Access Compliance Report

Public Rights-of-Way

Intersection ID: 43839	Main Street: DELUCA_DR	Cross Street: HAMEL_ST	Location: SE
ADA ID: C6747682B18B	Ramp Type: BlendTrans1	Initial Pass/Fail: Fail	Overall Compliance: No
		Severity Score: 10

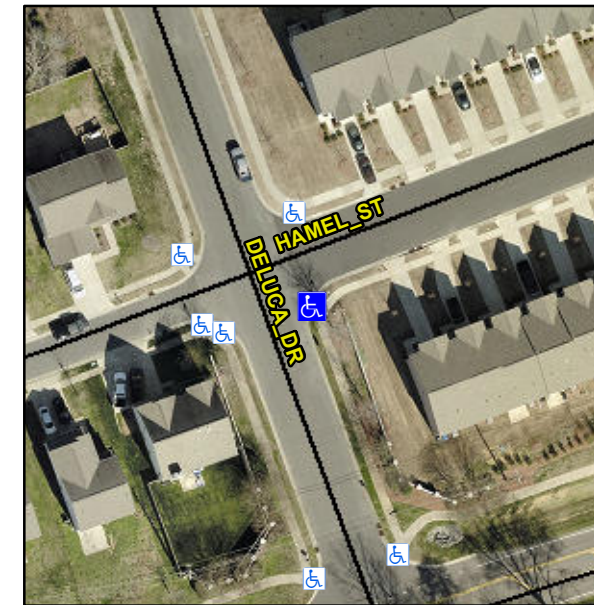
NO LT SW

Not Found, R304.5.1, R304.5.3

Compliance	Description	Data	Compliance	Description	Data
N/A	Ramp Length (in)	46.0	Yes	BlendTrans Slope (%)	4.9
No	Ramp Width (in)	47.5	No	BlendTrans XSlope (%)	3.9
N/A	Flare Type LT	N/A	N/A	Flare Type RT	N/A
N/A	Flare Slope LT (%)	N/A	N/A	Flare Slope RT (%)	N/A
N/A	Flare Traversable LT?	N/A	N/A	Flare Traversable RT?	N/A
N/A	Landing Length (in)	N/A	N/A	DWS Provided?	N/A
N/A	Landing Width (in)	N/A	N/A	DWS Contrast?	N/A
N/A	Landing Slope (%)	N/A	N/A	DWS Length (in)	N/A
N/A	Landing X Slope (%)	N/A	N/A	DWS Full Width?	N/A
N/A	Landing Curb? (Y/N)	N/A	N/A	DWS Offset (in)	N/A
N/A	Shared Landing?	N/A			
N/A	Gutter Ponding?	N/A	N/A	Gutter Slope (%)	N/A
N/A	Gutter Lip Ht (in)	0.5	N/A	Gutter X Slope (%)	N/A
N/A	Painted X Walk1?	No	N/A	Painted X Walk2?	No
	X Walk 1 Direction	To N		X Walk 2 Direction	To W
	X Walk 1 Width (in)	N/A		X Walk 2 Width (in)	N/A
	X Walk 1 Slope (%)	1.8		X Walk 2 Slope (%)	4.2
	X Walk 1 X Slope (%)	5.3		X Walk 2 X Slope (%)	2.6

Remove & Replace Curb Ramp With Two New Directional Ramps or Equivalent.
